Access Compliance Report

Public Rights-of-Way

(Curb Ramps)

Intersection ID: 21102	Main Street: S_TRYON_ST	Cross Street: WHITEHALL_PARK_DR	Location: S
ADA ID: 3D0AEBA12AA4	Ramp Type: Perp	Initial Pass/Fail: Fail	Overall Compliance: No
Severity Score: 12.5			
Codes/Mitigation Info/Possible Solution		Field Measurements/Component Compliance

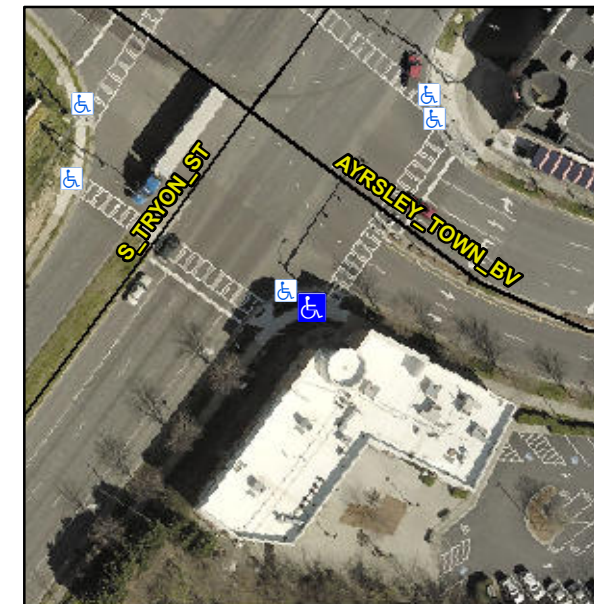
Not Found, R304.2.2

Compliance	Description	Data	Compliance	Description	Data
N/A	Ramp Length (in)	89.0	No	Ramp Slope (%)	8.8
Yes	Ramp Width (in)	70.5	Yes	Ramp XSlope (%)	1.2
N/A	Flare Type LT	N/A	N/A	Flare Type RT	N/A
N/A	Flare Slope LT (%)	N/A	N/A	Flare Slope RT (%)	N/A
N/A	Flare Traversable LT?	N/A	N/A	Flare Traversable RT?	N/A
N/A	Landing Length (in)	N/A	N/A	DWS Provided?	N/A
N/A	Landing Width (in)	N/A	N/A	DWS Contrast?	N/A
N/A	Landing Slope (%)	N/A	N/A	DWS Length (in)	N/A
N/A	Landing X Slope (%)	N/A	N/A	DWS Full Width?	N/A
N/A	Landing Curb? (Y/N)	N/A	N/A	DWS Offset (in)	N/A
N/A	Shared Landing?	N/A			
N/A	Gutter Ponding?	N/A	N/A	Gutter Slope (%)	N/A
N/A	Gutter Lip Ht (in)	N/A	N/A	Gutter X Slope (%)	N/A
N/A	Painted X Walk1?	Yes	N/A	Painted X Walk2?	N/A
	X Walk 1 Direction	To NE		X Walk 2 Direction	N/A
N/A	X Walk 1 Width (in)	111.0	N/A	X Walk 2 Width (in)	N/A
	X Walk 1 Slope (%)	1.6		X Walk 2 Slope (%)	N/A
	X Walk 1 X Slope (%)	1.9		X Walk 2 X Slope (%)	N/A

Remove & Replace Entire Ramp.
